STAFF RECOMMENDATION
128 2nd Avenue North
January 21, 2015

Application: New construction- addition
District: Second Avenue Historic Preservation Zoning Overlay
Council District: 19
Map and Parcel Number: 09306207900
Applicant: Manuel Zeitlin, Architect
Project Lead: Allison Asbrock, robin.ziegler@nashville.gov

<p>Description of Project: This application is for the construction of a one-story rooftop addition.</p> <p>Recommendation Summary:</p> <p>Staff recommends approval with the condition that:</p> <ul style="list-style-type: none"> • The railing never have anything hanging on it such as lights, speakers, or signage and that the setback area not have any overhead elements added without a revision to the permit such as lighting, signage or speakers; and • All materials be approved by staff prior to purchase and installation <p>With these conditions, Staff finds the project to meet the design guidelines for additions in the Second Avenue Historic Preservation Zoning Overlay.</p>	<p>Attachments</p> <p>A: Photographs</p> <p>B: Site Plan</p> <p>C: Elevations</p>
---	---

1 ROOF PLAN
 1/16" = 1'-0"

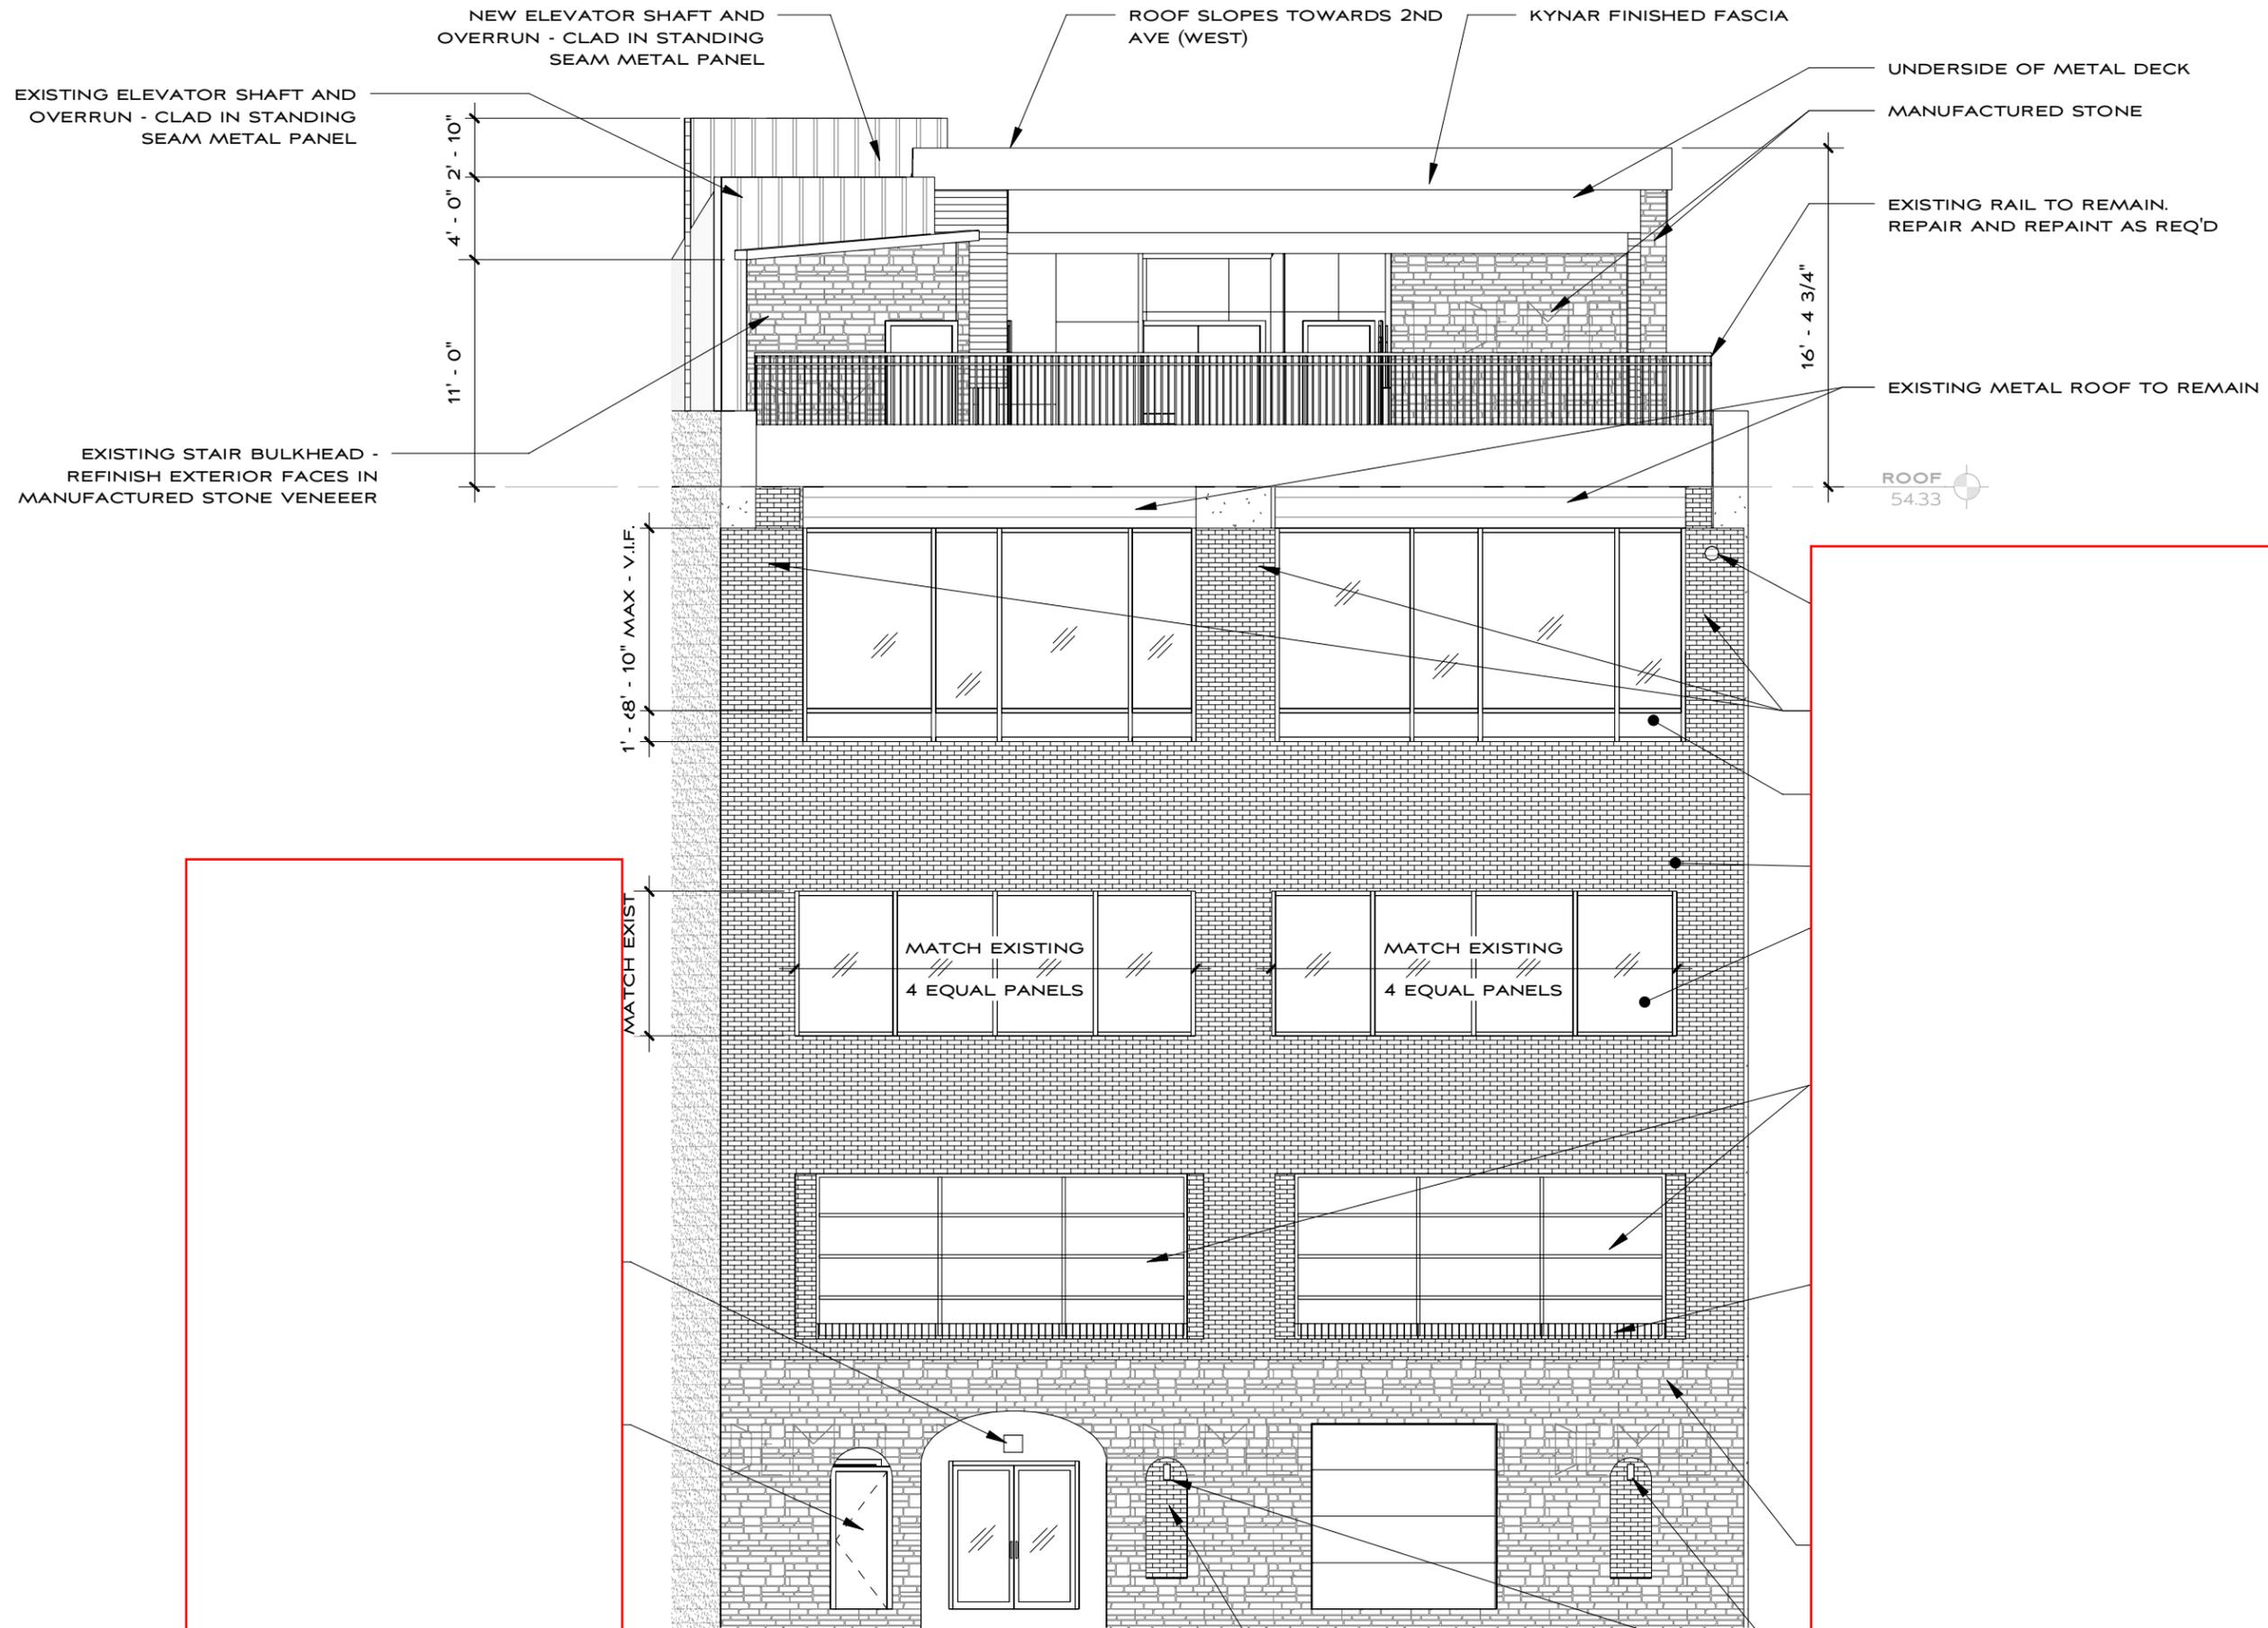
The rooftop addition has a front setback of seventy-eight feet, six and three quarters inches (78' 6 ¾") from the Second Avenue façade and a rear setback of fourteen feet, seven and one eighth inches (14' 7 1/8") from the First Avenue façade. The main rear massing of the addition is setback approximately forty-four feet, three inches (44' 3") from the First Avenue façade. Both the front and rear setbacks are appropriate according to the design guidelines which require a minimum of a thirty foot (30') setback on Second Avenue and a ten foot (10') setback on First Avenue.

Railings will not be added. The existing rear railing flush on the First Avenue façade will be repaired and retained. The retention of this railing eliminates the need to meet the eight foot (8') setback for railings. Provided that this railing does not support lights, speakers, signage, or any other objects staff approves the use of this railing for the rooftop addition.

The proposed rooftop addition will be the full width of the property at feet approximately fifty feet (50') wide. The proposed rooftop addition will be a minimal addition. The square footage of the roof area is approximately nine thousand, four hundred and eighty square feet (9,480 sq. ft.), and the addition will use approximately only four thousand, one hundred and thirty square feet (4,130 sq. ft.) for its finished dining area.

The proposed roof form is a variety of flat roof surfaces that have a slight downslope toward Second Avenue. Staff finds this roof form to be appropriate as the majority of historic roof forms in the area are parapet roofs. The variety of roof surfaces is a compatible design as the roof will be minimally visible from the First and Second Avenue street levels.

- The railing never have anything hanging on it such as lights, speakers, or signage and that the setback area not have any overhead elements added without a revision to the permit such as lighting, signage or speakers; and
- All materials be approved by staff prior to purchase and installation

1 2ND AVE ELEVATION
1/8" = 1'-0"

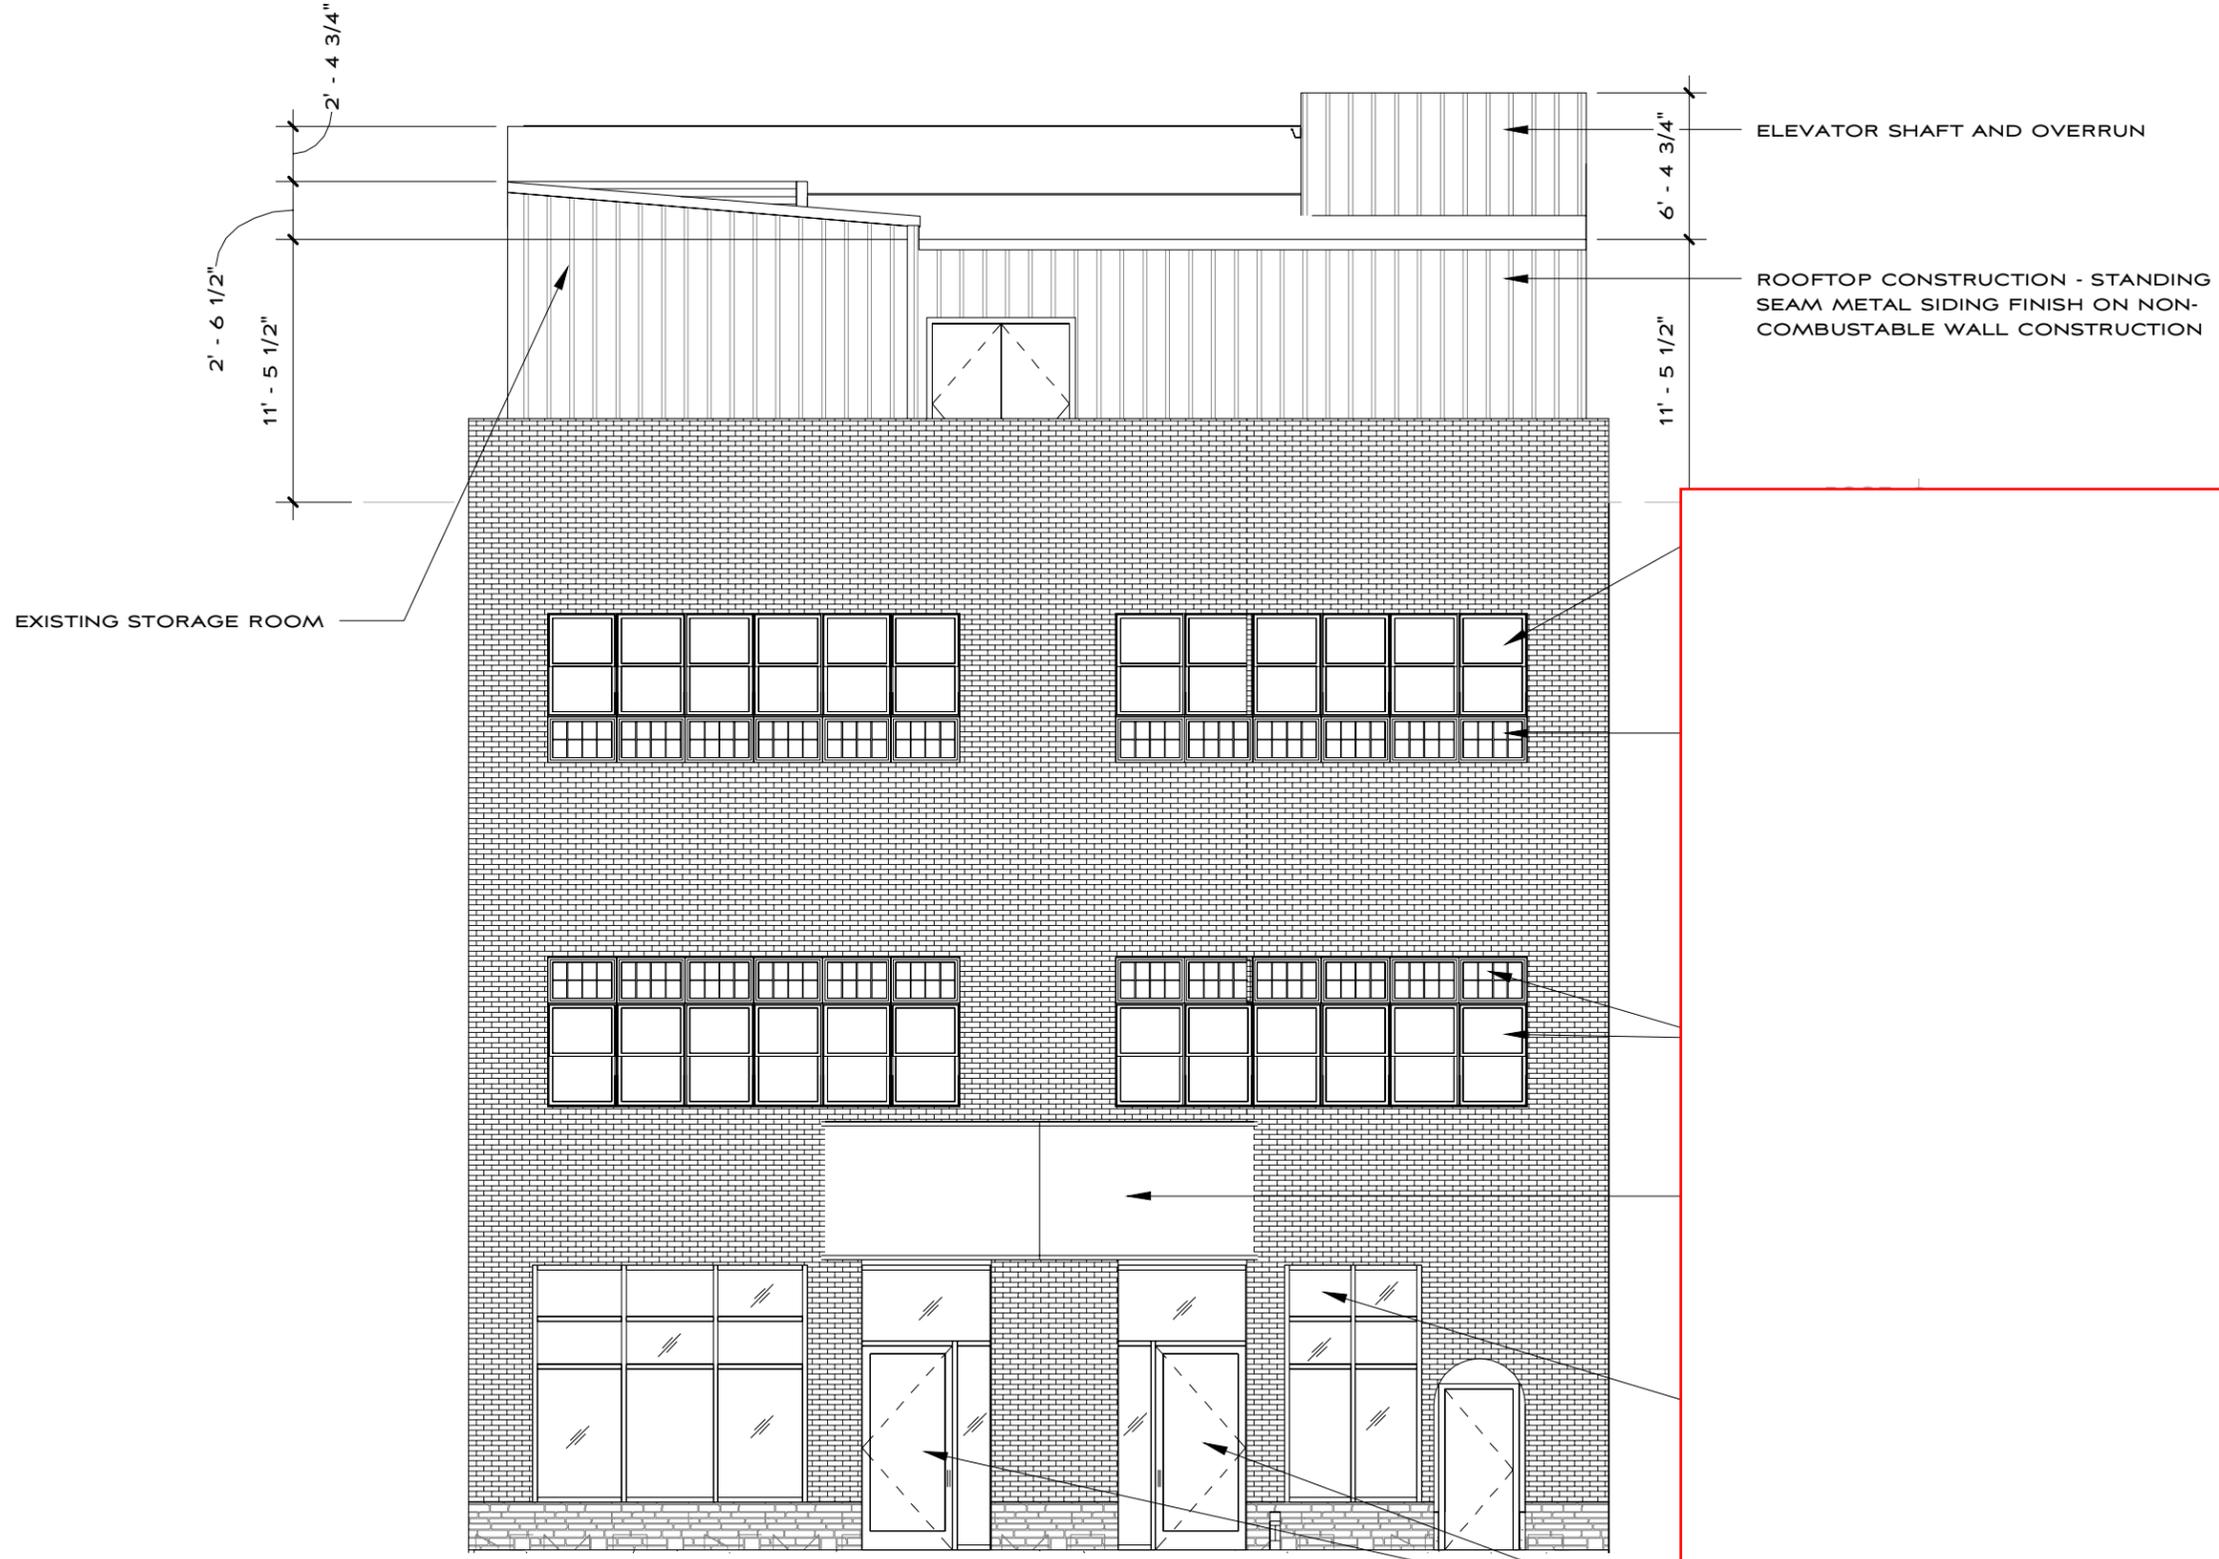
The design of the Second Avenue façade does not meet the guidelines for proportion and rhythm of window openings as it is a large expanse of standing seam metal cladding punctuated only by a centrally located door; however this facade of the addition will be minimally visible and is therefore appropriate. Staff finds the rhythm of openings on the more visible First Avenue façade to be appropriate as there a variety of enclosed utilities that create a dimensioned façade.

The proposed material for the Second Avenue façade is standing seam metal panels. Although not typical cladding for this district, the addition is new construction that will be minimally visible. Staff recommends additional review of the door on the Second Avenue façade as it was not indicated on the plans.

Staff recommends final review of all materials including colors, for both facades. With this condition, Staff finds this project meets section II.F of the design guidelines.
